SUBJECT: ISSUANCE OF AMENDMENT FOR NINE MILE POINT NUCLEAR STATION UNIT NO. 1
(TAC NO. 74754)

Amendment No. 125
License No. DPR-63

SAFETY EVALUATION BY THE OFFICE OF NUCLEAR REACTOR REGULATION
RELATED TO AMENDMENT NO. 125 TO FACILITY OPERATING LICENSE NO. DPR-63
NIAGARA MOHAWK POWER CORPORATION
NINE MILE POINT NUCLEAR STATION UNIT NO. 1
DOCKET NO. 50-220

FIGURE 3.4.1

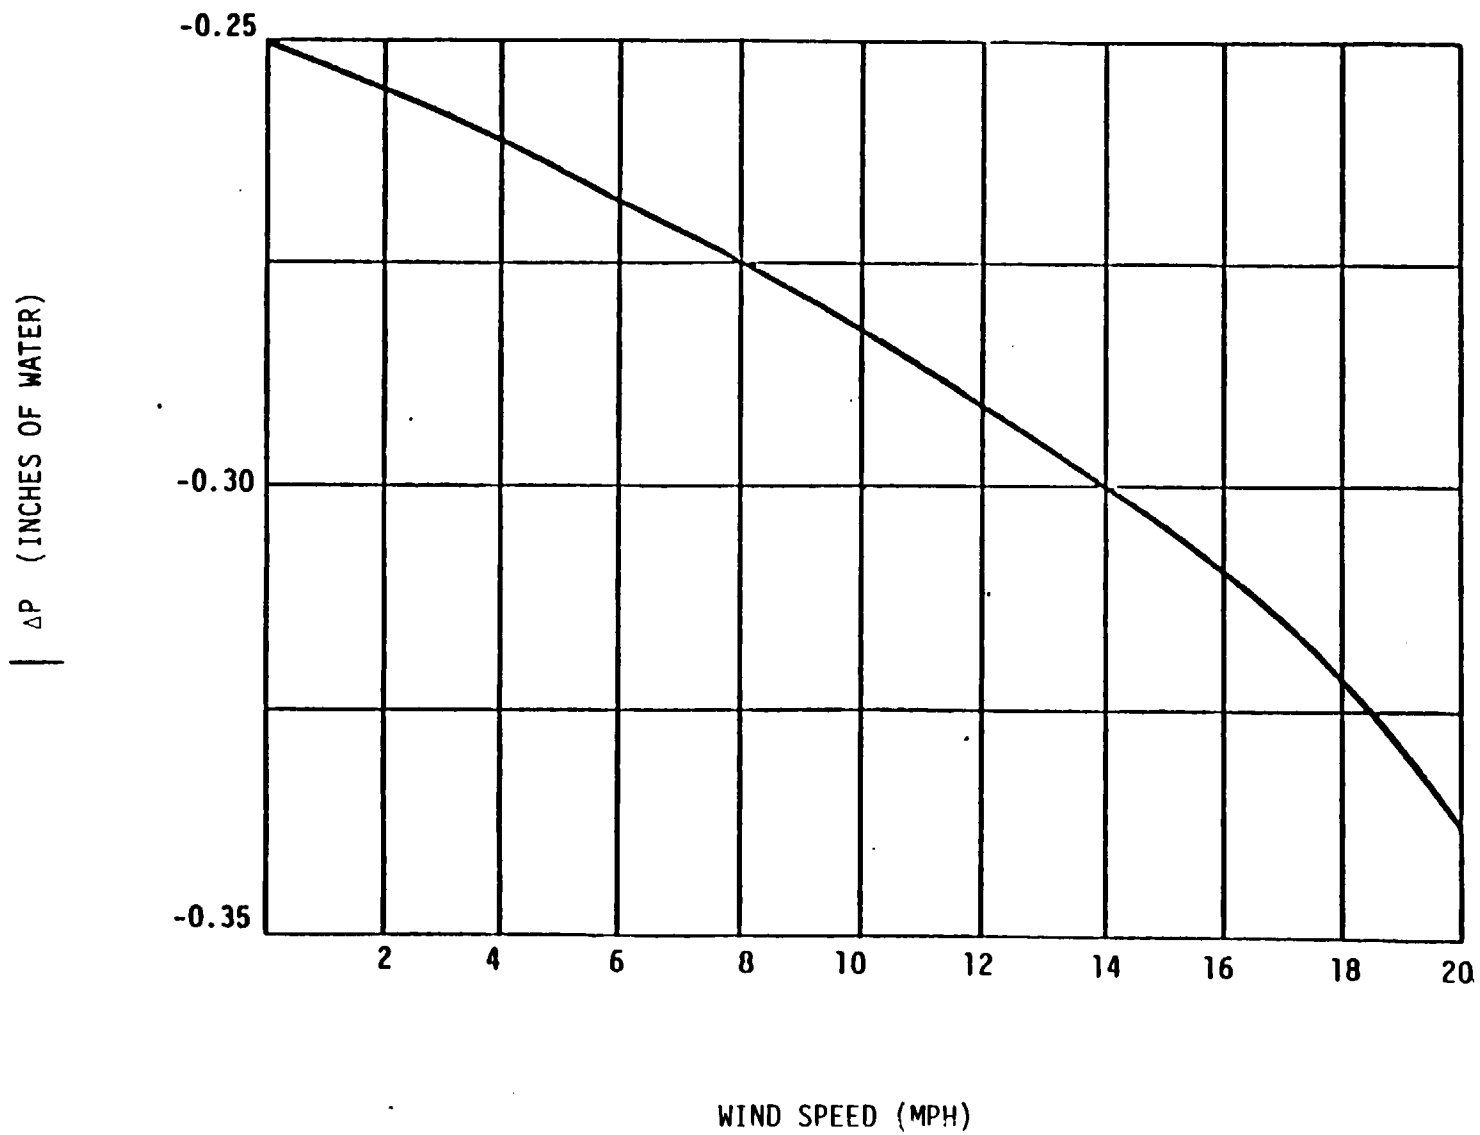
The amendment revises Technical Specification Figure 3.4.1 to correct errors of omission in the labeling of the graph on the figure. The revisions to Figure 3.4.1 clarify that Reactor Building pressures specified thereon are actually differential pressures.

By letter dated May 26, 1989, as amended January 5, 1990, Niagara Mohawk Power Corporation (the licensee) submitted a request for changes to the Nine Mile Point Nuclear Station Unit No. 1, Technical Specifications (TS). The requested changes would revise TS Figure 3.4.1 (Reactor Building Pressure) to clarify that the reactor building pressures specified thereon are actually reactor building differential pressures.

The proposed revisions to TS Figure 3.4.1 would clarify that the reactor building pressures specified thereon are actually reactor building differential pressures. The NRC staff has reviewed the proposed changes and has determined that the Figure 3.4.1 pressures were obviously intended to be differential pressures. The proposed changes clarify the original intent of the figure. Therefore, the proposed revisions to Figure 3.4.1 are acceptable.

REACTOR BUILDING DIFFERENTIAL PRESSURE
